The Underpass Option at Austin Street: Impacts and Comparison Against the 7-Lane Surface Option

An analysis of the City's proposed "Underpass Option" for the intersection of Rutherford Ave and Austin Street.

Northeastern University

January 29, 2018

Heavy right-turn flows that conflict with pedestrians in the Underpass Option

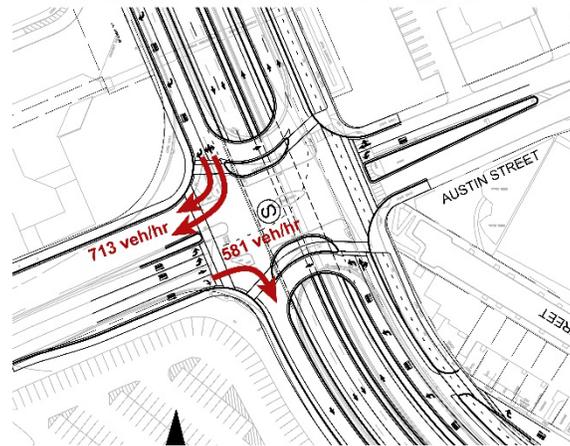
Consider first crossing Austin Street on the Gilmore Bridge side. The way the intersection is laid out, the only time its WALK interval could run is concurrently with the southbound traffic on Rutherford Ave. Concurrent pedestrian phases are normal and acceptable when the right-turning volume is small; MassDOT allows concurrent pedestrian phases when the right turning volume is up to 250 vehicles per hour. But the right-turning volume here is more than 700 vehicles per hour! And what's more, cars will be allowed to turn right from two lanes! Clearly, it would not be safe to have pedestrians cross in the face of this massive conflict.

The southern crossing of the southbound surface road has the same kind of conflict. It will be concurrent with the eastbound traffic leaving the Gilmore Bridge, presenting a conflict with 310 vehicles per hour turning right in the a.m. peak, and 550 turning right in the p.m. peak, more than double the MassDOT limits for conflicting right turns.

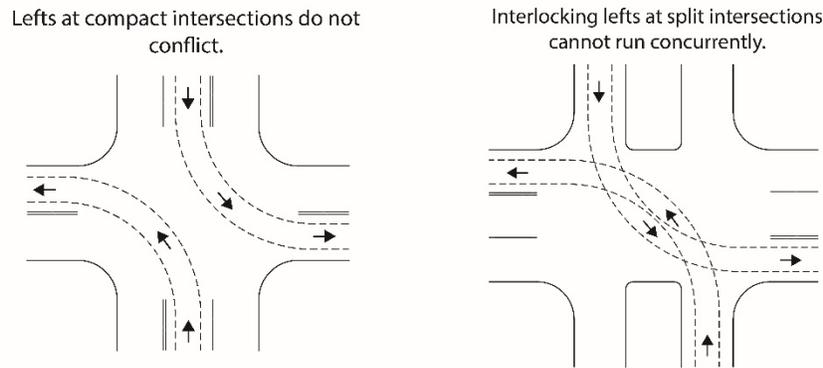
First, ***the underpass consumes an inordinate amount of space, leaving insufficient space for the surface roads.*** One might think that, because the City’s underpass option cuts the number of travel lanes from 6 (existing) to 3 (proposed, with 2 lanes southbound and 1 lane northbound), the space consumed by the underpass will shrink a lot. But no – the overall space consumed by the underpass shrinks by only 10 ft, because an underpass – with unavoidably high speed traffic – requires wide shoulders, as well as space for structural walls. As a result, the surface roads are limited to 2 lanes each, which isn’t enough to serve the heavy traffic trying to turn onto the Gilmore Bridge.
